John K. Wood  
Vice President - Nuclear  
Davis-Besse

Docket Number 50-346

December 20, 1996

Subject: Comments On NRC's Report Concerning "Resolution Of Spent Fuel Storage Pool Safety Issues: Issuance Of Final Staff Report And Notification Of Staff Plans To Perform Plant-Specific, Safety Enhancement Backfit Analyses, Davis-Besse Nuclear Power Station", (TAC No. M88094)

FUNCTIONAL DRAWING SPENT FUEL POOL COOLING SYSTEM		
FIGURE NO.	REV.	
FIGURE 9.1-5	D

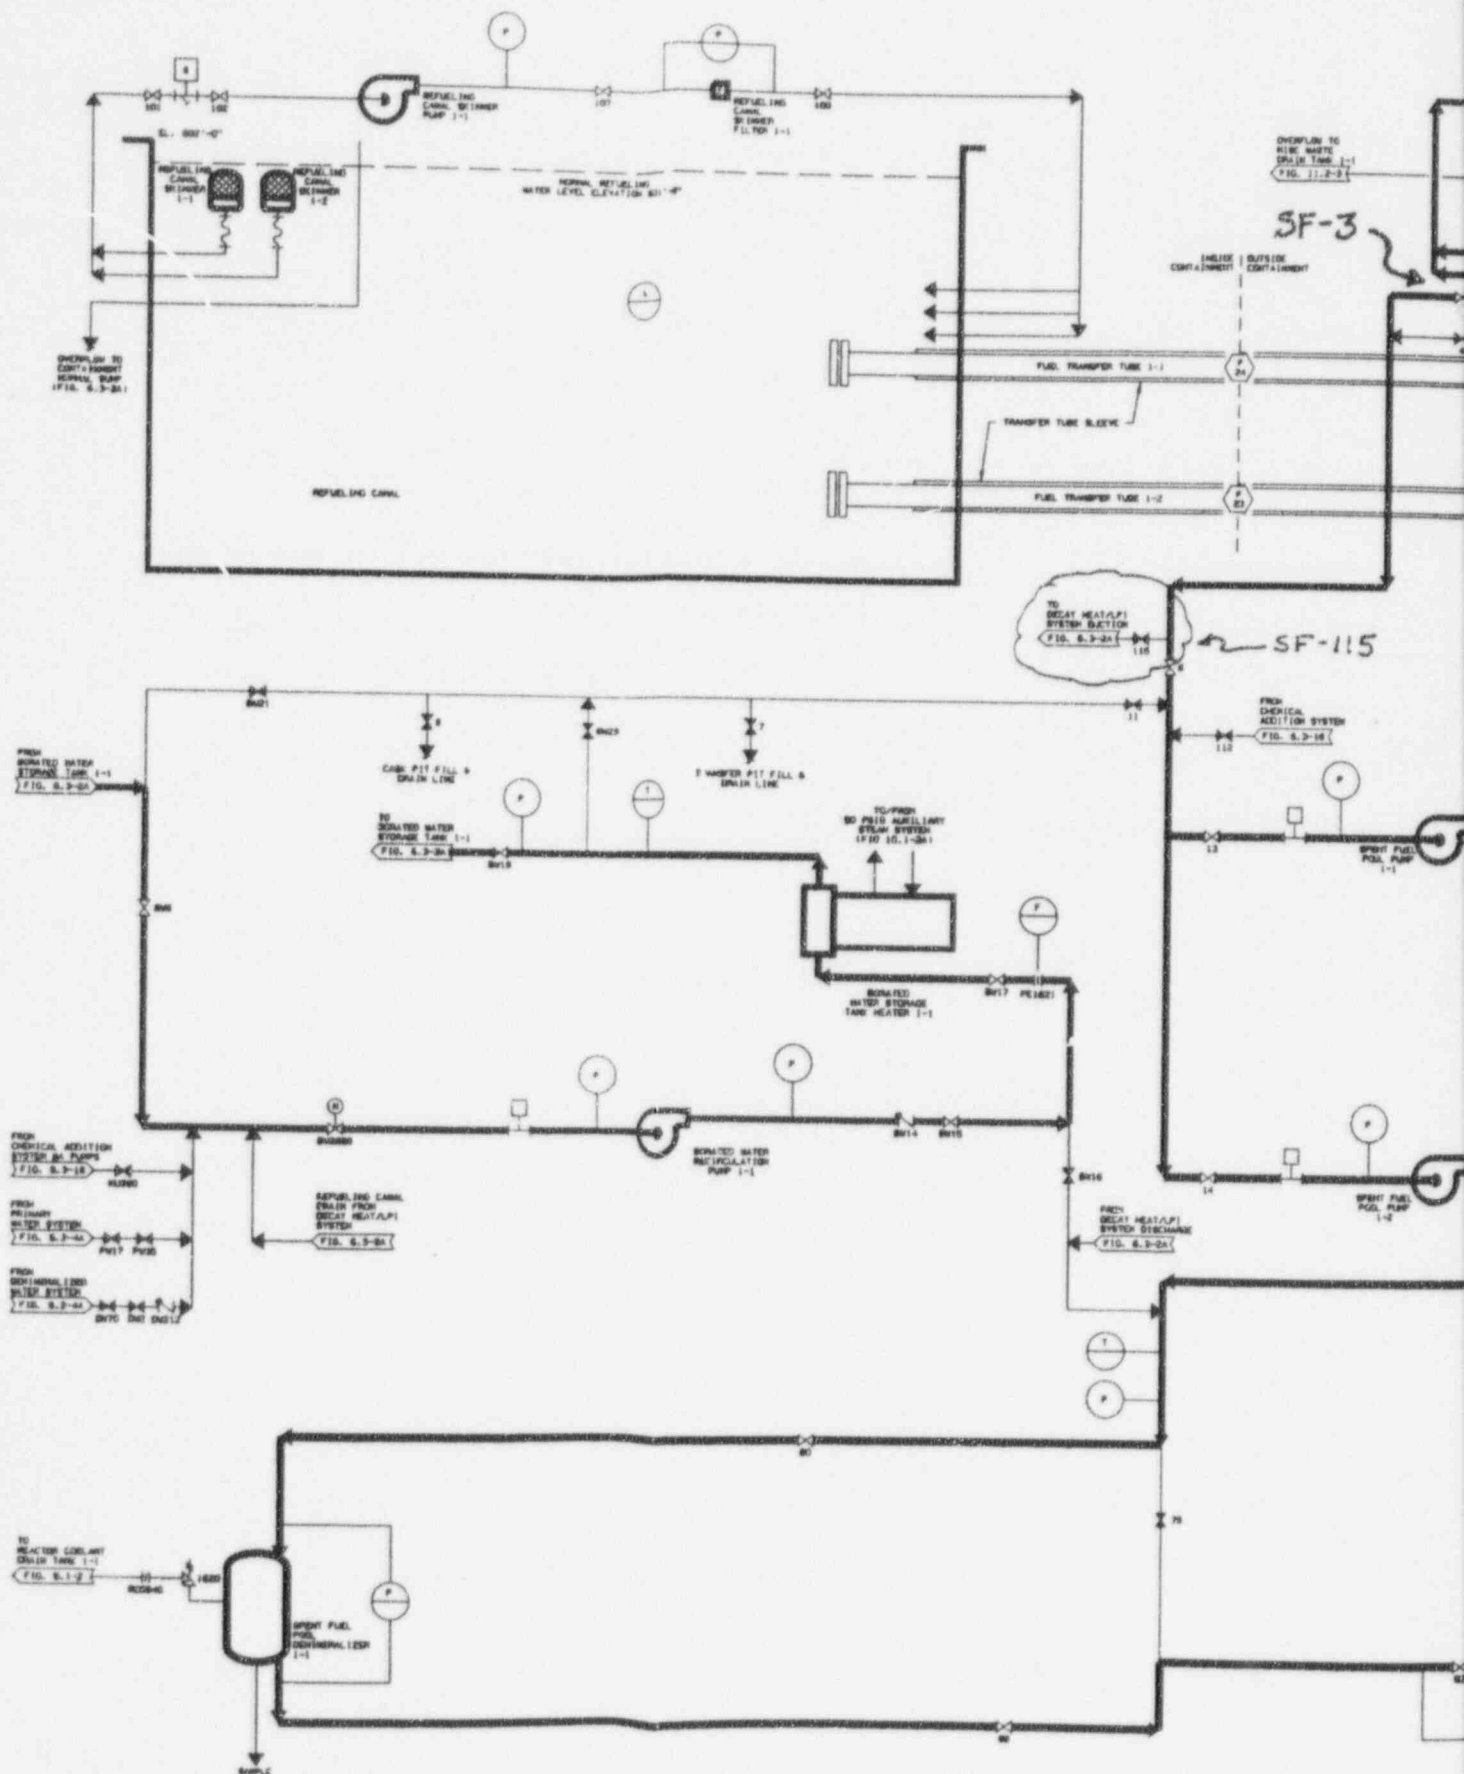
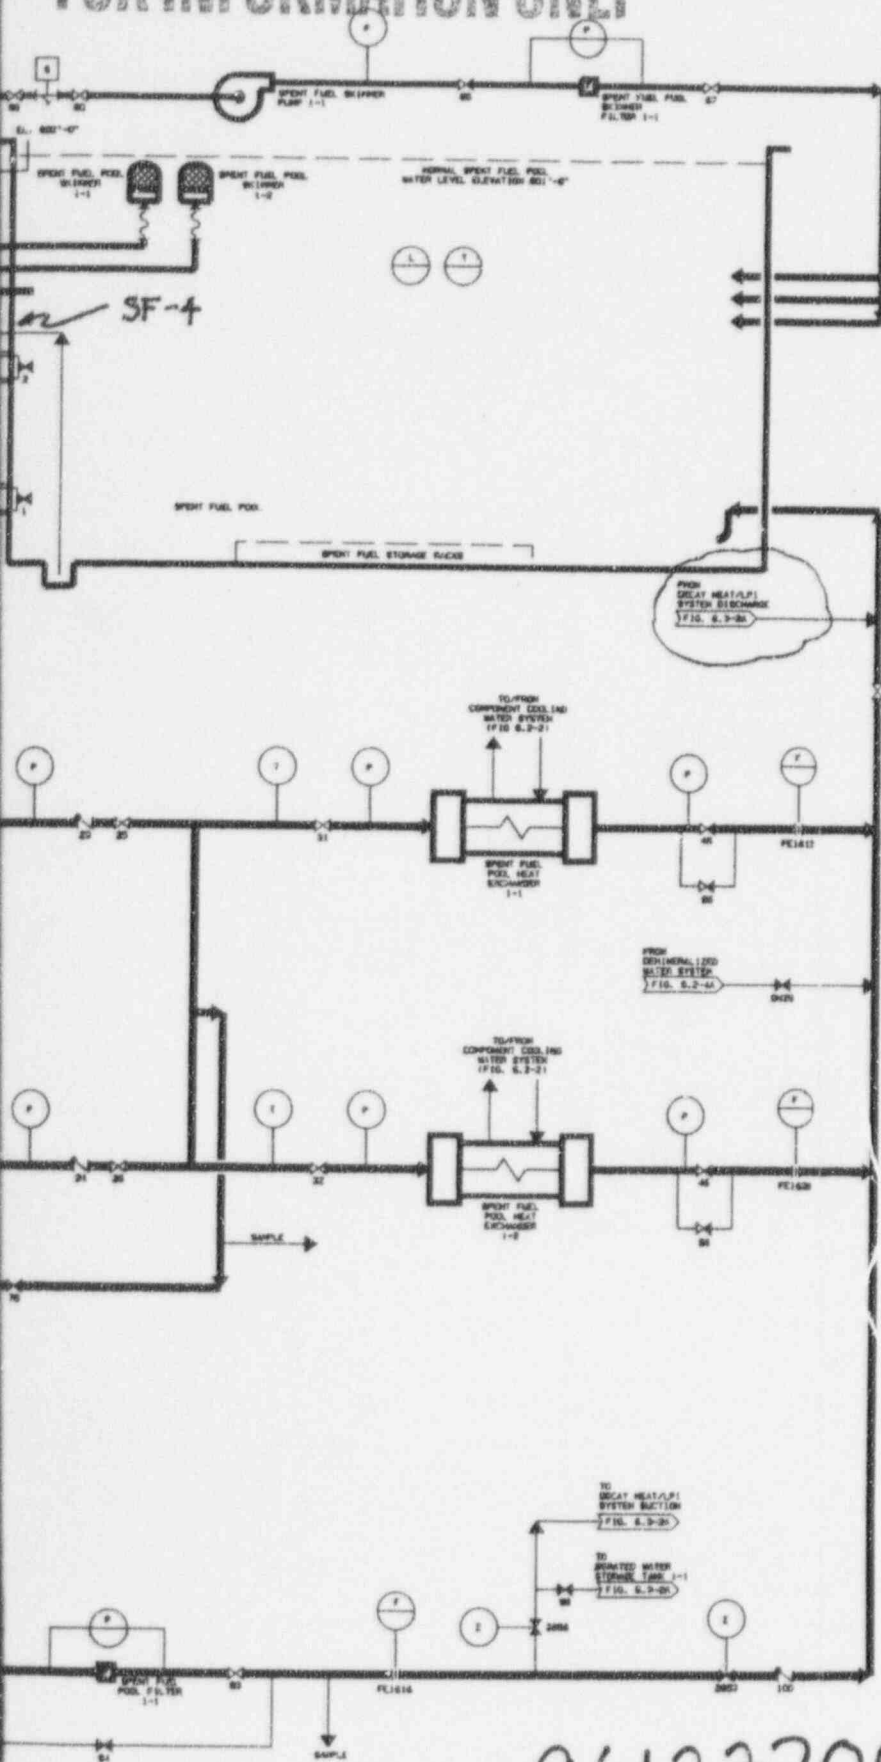
The Spent Fuel Pool (SFP) lacks passive anti-siphon devices for piping systems that could, through improper operation of the system, reduce coolant inventory to a level that provides insufficient shielding and eventually exposes stored fuel. Because this piping is connected to the SFP cooling and cleanup system through a normally locked closed valve and lacks passive anti-siphon protection, mispositioning of the normally locked-closed valve coincident with a pipe break or refueling water transfer operation could reduce the SFP coolant inventory by siphon flow to a level below the top of the stored fuel.

The specific concern is that the SFP drain line containing valve SF-4 is not protected by an anti-siphon device and, in the event of misoperation of valve SF-4, the SFP could be drained to the extent that spent fuel would be exposed to air. Attached DBNPS Updated Safety Analysis Report (USAR) Figure 9.1-5 is a depiction of the SFP and SFP Cooling System.

This 4-inch diameter line and normally closed manual valve SF-4 are seismically qualified. The valve SF-4 drain line extends to the lowest portion of the SFP (approximately elevation 563'). Valve SF-4 is located at elevation 590' which is greater than 9 feet above the spent fuel assemblies (approximately elevation 577' 5"). As this line is seismically-qualified, a break is not considered credible and it is assumed to remain intact during a seismic event and is, therefore, not protected by an anti-siphon device.

This 4-inch diameter drain line shares a common suction line to the SFP cooling pumps with the 10-inch diameter SFP suction line as depicted on USAR Figure 9.1-5. This suction line to the SFP cooling pumps contains normally open manual valve SF-3. The normal cooling path for SFP cooling is through normally open valve SF-3, through the SFP cooling pump(s), SFP heat exchanger(s), valve SF-4 and discharge to the SFP. The valve SF-3 line suction point on the SFP is at elevation 597' which is greater than 9 feet above the spent fuel assemblies.

The SF-4 drain line is not used to manage the water level in the SFP. There are no normal or abnormal system operating procedures that require operation of valve SF-4. Protection against draining of the SFP by misoperation of manual valve SF-4 is provided by the SFP cooling pumps' suction line containing normally open manual valve SF-3. Since this line is in continuous operation, should the SFP water level drop below the valve SF-3 suction point (elevation 597'), the SFP cooling pumps will lose suction and greater than 9 feet of water will be maintained over the spent fuel. Additionally, changes in SFP water level would be detected by a low water level annunciator alarm and/or SFP area radiation monitors alarming in the Control Room.

It is unlikely that misoperation of normally closed valve SF-4 and normally open valve SF-3 will occur simultaneously. However, to further protect against this misoperation, Toledo Edison plans to lock closed or remove the handwheel from valve SF-4, whichever is determined to be more effective in preventing a potential misoperation.

Toledo Edison believes the safety improvement from these actions are comparable to cutting and capping the valve SF-4 line. Misoperation of valve SF-4 would require obtaining permission to open valve SF-4 or require permission to install the handwheel. Should valve SF-4 be opened, draining of the SFP to a level where spent fuel would be exposed would also require valve SF-3 to be closed, and failure of the low level alarm and radiation monitor alarms to alarm in the Control Room.

Capping of this valve is estimated to cost approximately \$20,000. However, more critical than cost, this modification would require the complete interruption of SFP cooling for a minimum of 24 hours. As depicted on USAR Figure 9.1-5, SFP cooling by either the SFP Cooling System or the Decay Heat Removal System is through the valve SF-3 suction line which cannot be isolated from SF-4.

FUNCTIONAL DRAWING DECAY HEAT REMOVAL/ LOW PRESSURE INJECTION SYSTEM		
FIGURE NO	REV	
FIGURE 6.3-2A	1

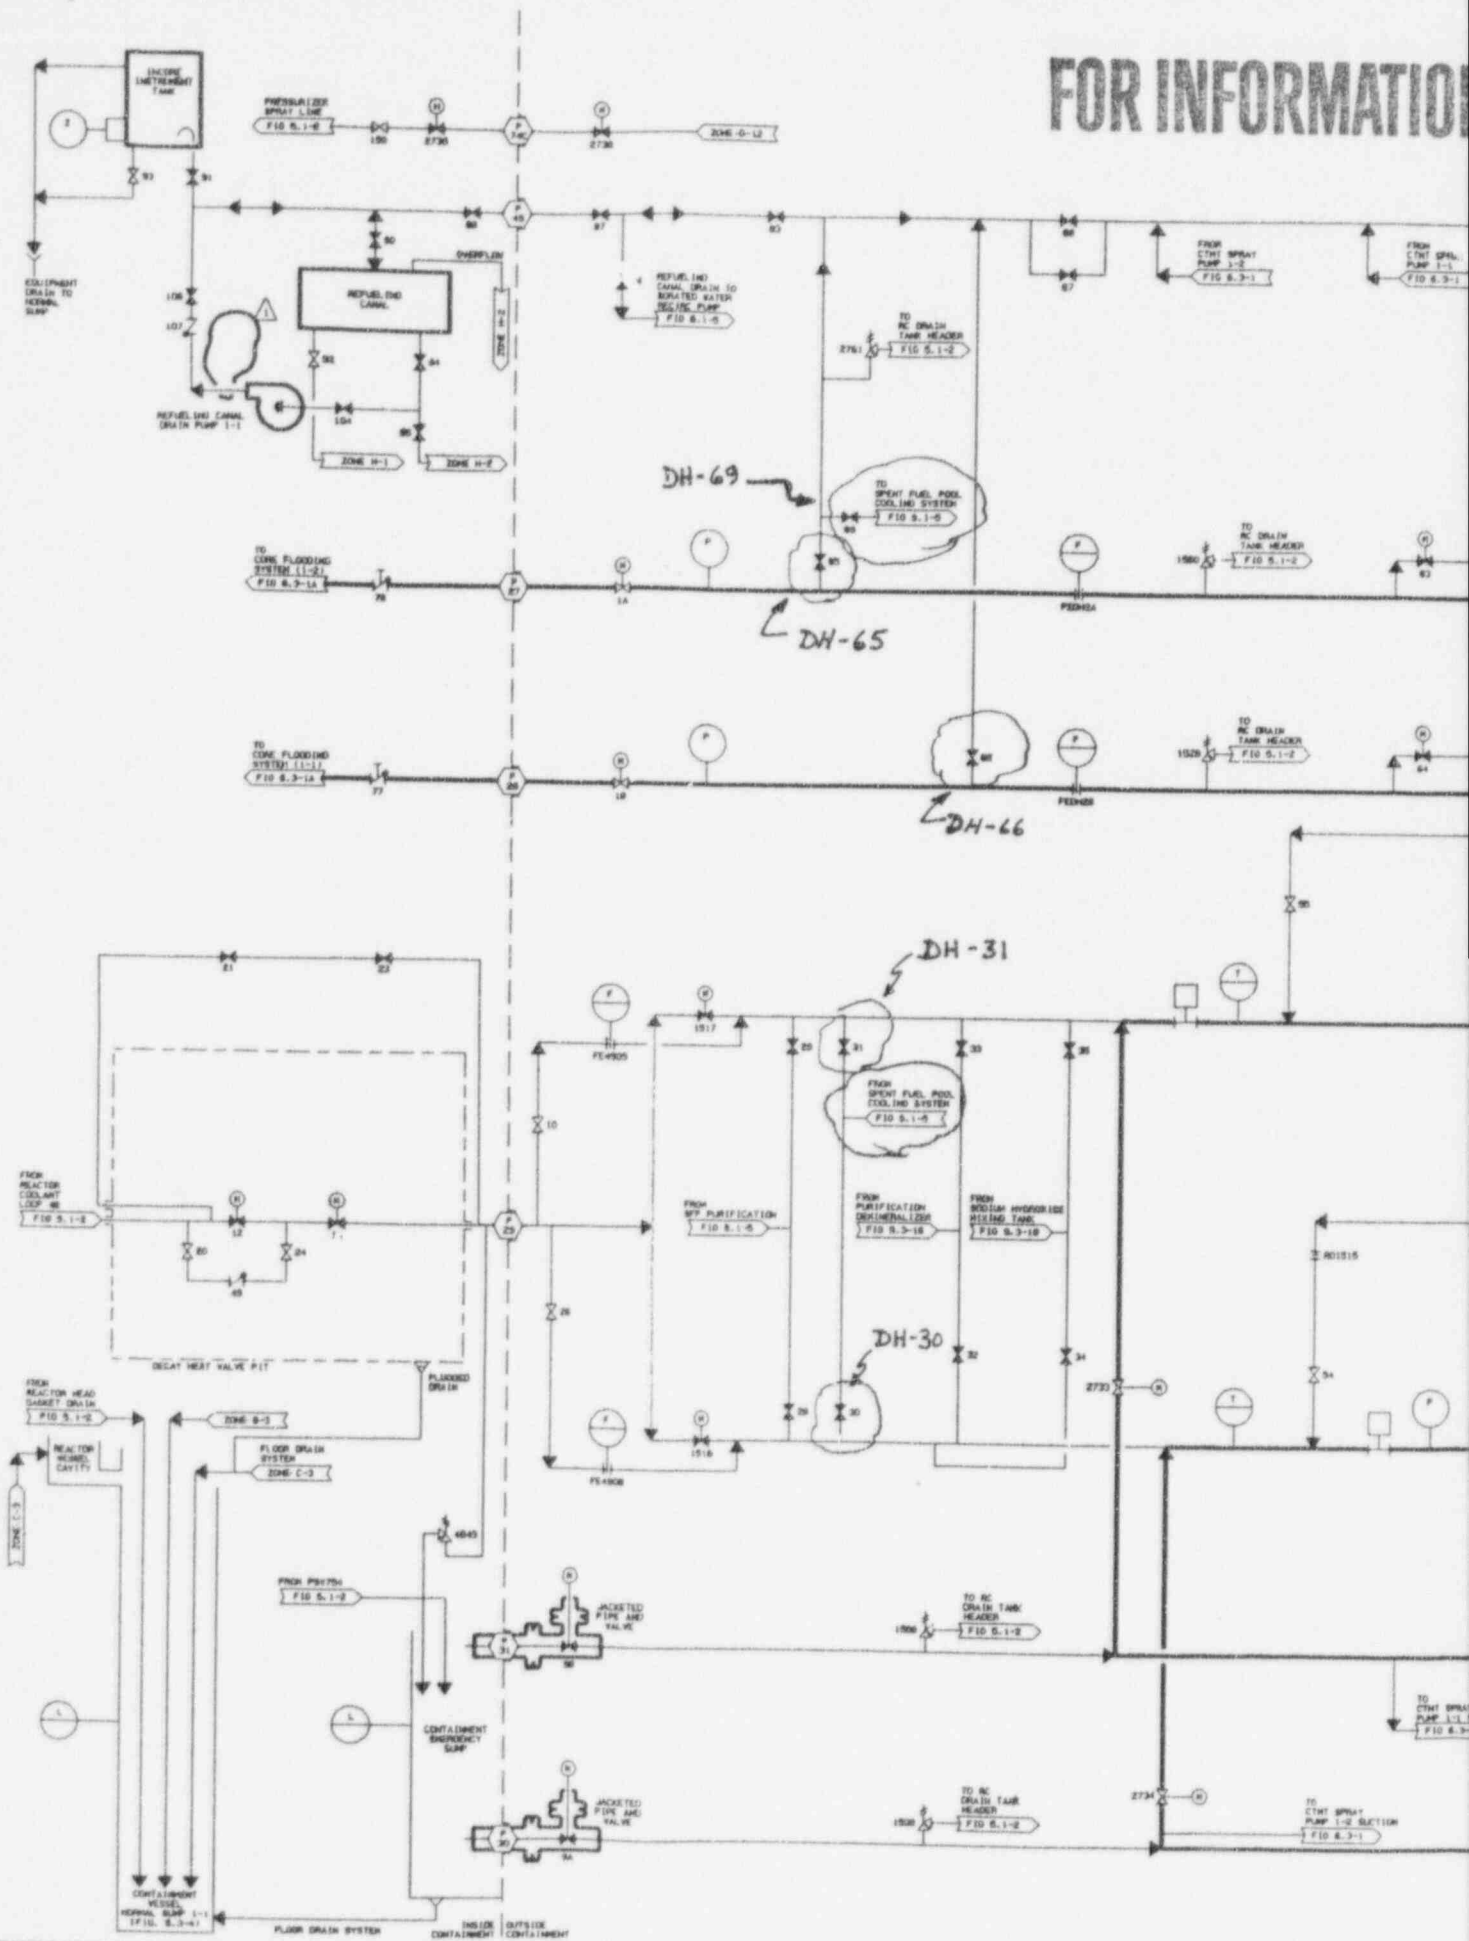
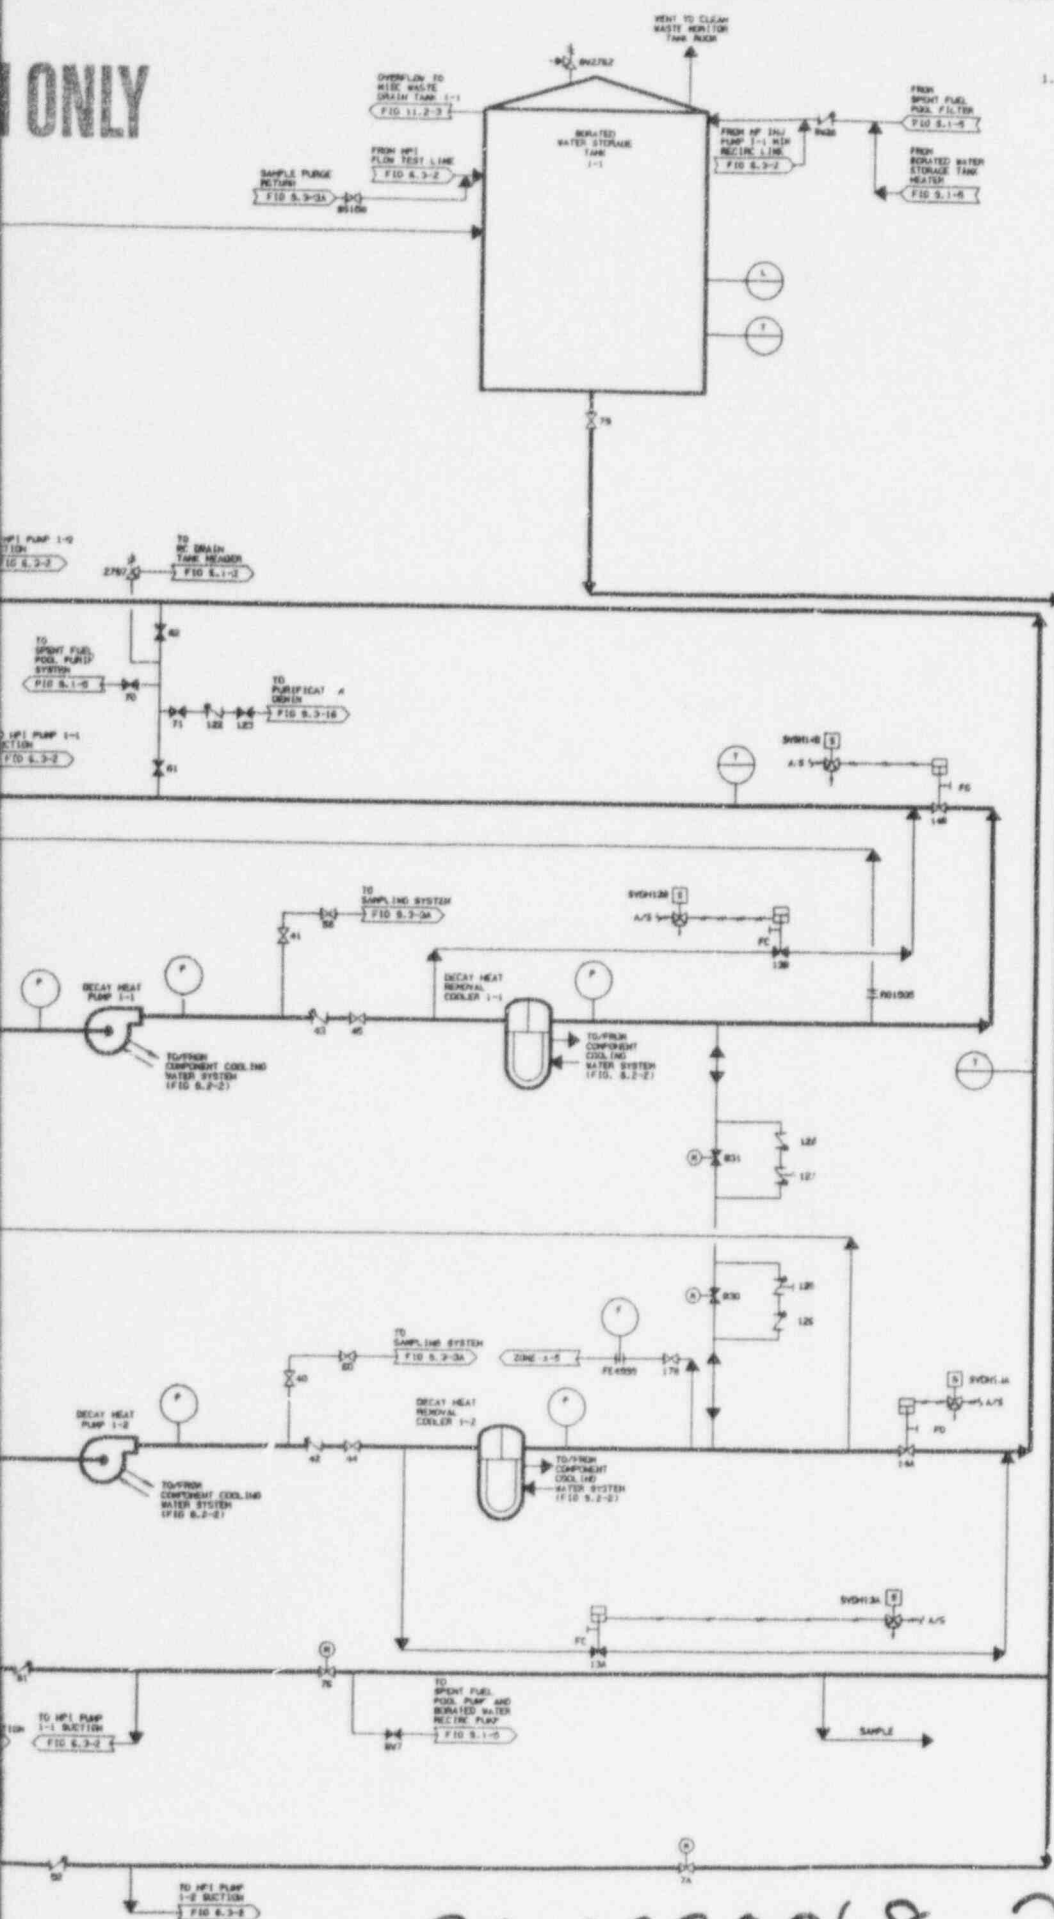
The Davis-Besse Nuclear Power Station appears to be reliant on infrequently operated backup SFP cooling systems to address long-term loss of off-site power (LOOP) events and mechanical failures.

The Decay Heat Removal (DHR) System, which has a higher heat removal capacity, serves as a backup system to the SFP Cooling System. Attached USAR Figure 6.3-2a is a depiction of the DHR System and the cross connection to the SFP Cooling System. The DHR System provides Seismic Class I and Class 1E powered safety grade cooling for the SFP. The DHR System is the system that is relied upon following a loss of off-site power (LOOP) to provide cooling to the SFP. The DHR pumps are electrically supplied by the Class 1E Emergency Diesel Generators following a LOOP. The DHR System is also available to remove the decay heat from the SFP when the entire core is off-loaded into the SFP.

The two systems are connected with a permanently installed 10-inch diameter line. Two normally closed gate valves (SF-115, DH-69) are used to provide isolation between the DHR System and the SFP Cooling System. The normal

cooling path for the DHR System cooling the SFP is through normally closed valve SF-115, through normally locked closed valve DH-30 (or -31) through the DHR pump, through the DHR heat exchanger, through normally locked closed valve DH-65 (or -66) and through normally closed valve DH-69 discharging to the SFP. This operation is controlled by procedure DB-OP-06012, "Decay Heat and Low Pressure Injection System Operating Procedure".

A complete loss of cooling is not considered credible since the DHR System serves as a readily available backup to the SFP Cooling System, should one be required.
